MAC-ENC-MTP-047

REHABILITATION STRATEGY

The Rehabilitation Strategy (the Strategy) is the standard for rehabilitation at Hunter Valley Energy Coal Pty Ltd (HVEC). The Strategy provides a framework for landform design and revegetation aligned with Regulator and community expectations.

Figure: 3

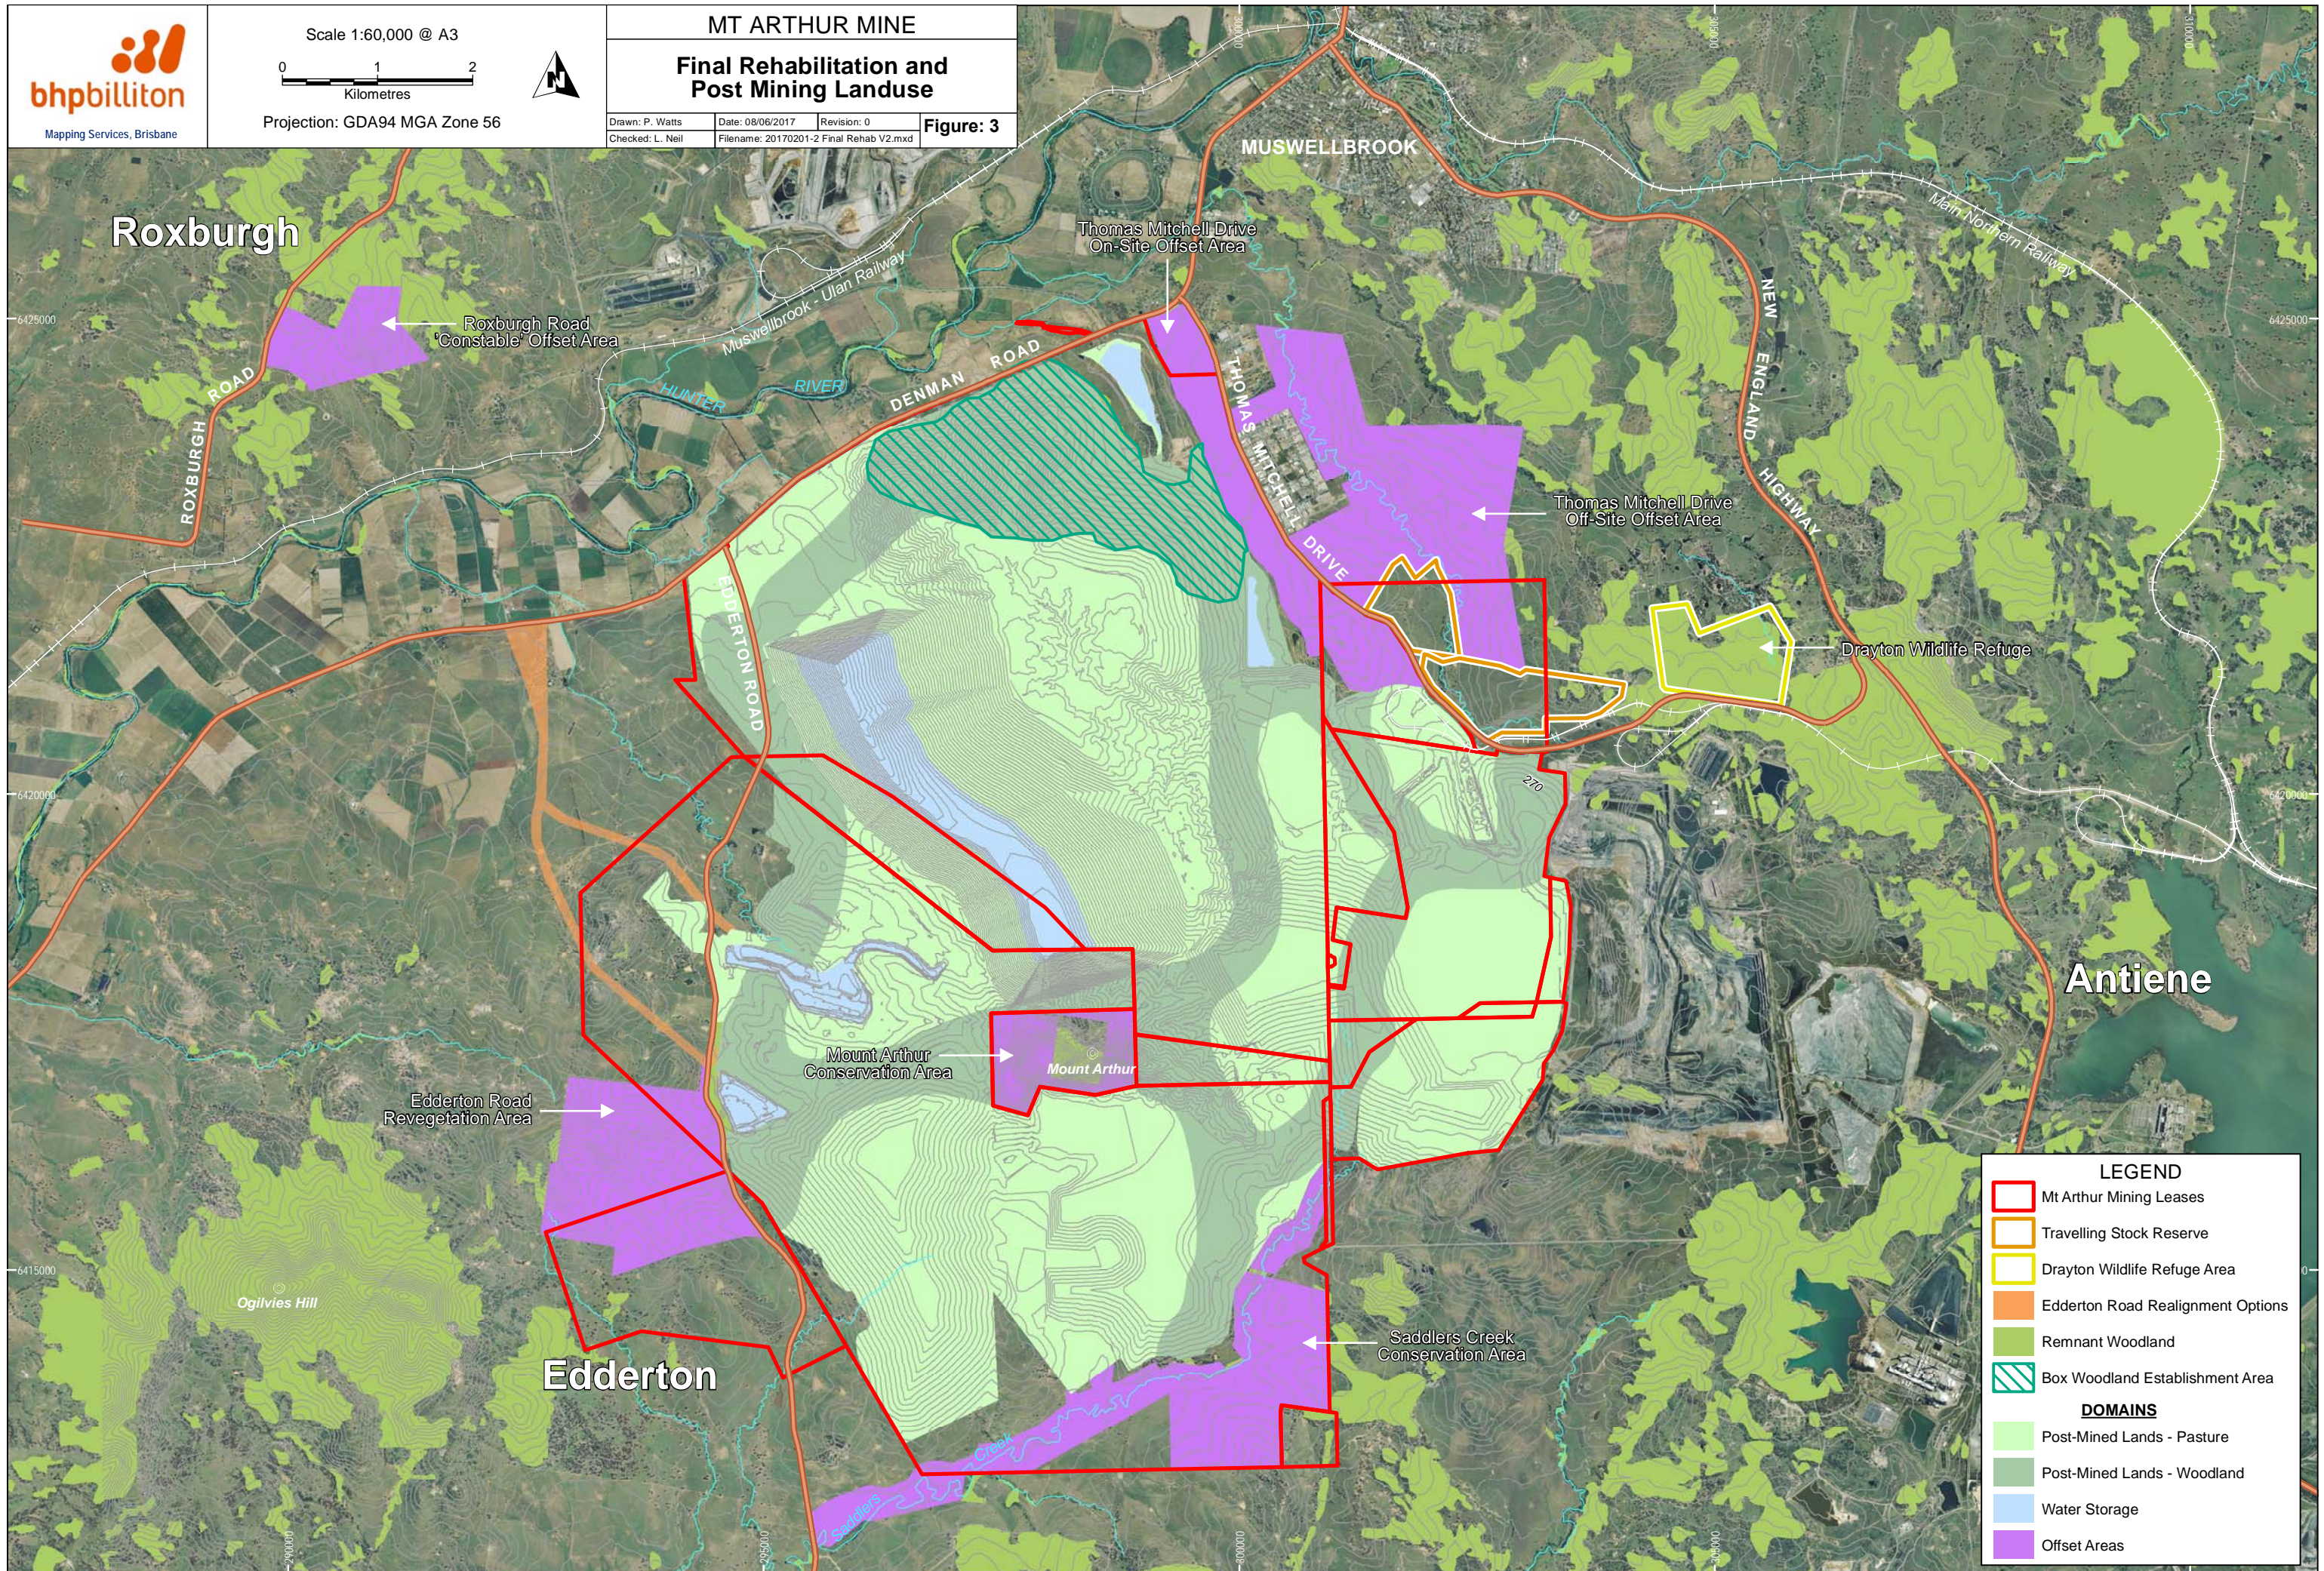
- *The final landform plan is required to clearly indicate as to where the 500ha of White Box Yellow Box Blakely's Red Gum Woodland will be established.*
- *Further clarity is required in regards to the breakdown of the 2,642 ha of self-sustaining woodland ecosystems to be established and where they will be located on site.*

- *Mt Arthur Coal is required to rehabilitate at least 33 hectares of Class II agricultural capability land. The Strategy needs to show where this area will be established as well as outline the location of other pasture areas that are to be established and to what capability.*

- Vegetation types, and pasture locations are shown in Figure 3b of the MOP and figure 3 of the new rehabilitation strategy.
 - Further staged montages will be included in the Strategy for MacLeans area. Labels on the montage will be improved for explanation
